# Improving cycling in the proposals for Picardy Place

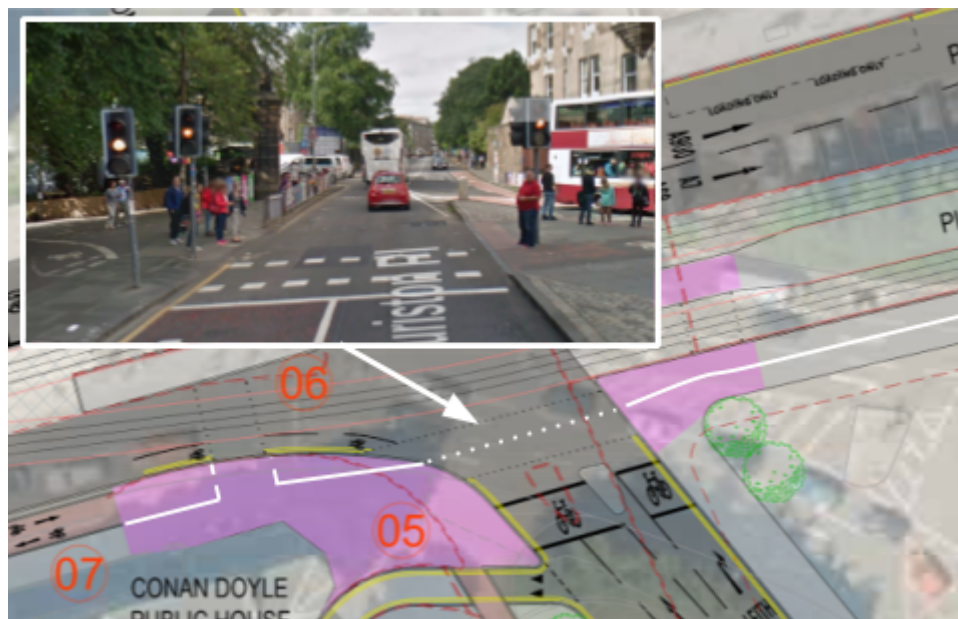
A cycleway across the north side of the island was included in previous plans but has disappeared from the current proposals. It is *crucial* that this cycleway is re-instated as this route – from the CCWEL on York Place to the new segregated cycleway on Leith Walk – is the single biggest desire line for cyclists across the entire junction!

From discussion with officers, I understand that the cycleway was removed from the plans due to concerns about conflict with pedestrians. Rather than remove the cycleway, I ask that you consider options to provide it in a manner that reduces conflict. Additionally, it should be recognised that the current proposal to route west/east cyclists via the island at the south will only create worse conflict due to the small size of the island and awkward angles that are hard to handle on a bicycle (worse still with cargo bikes).
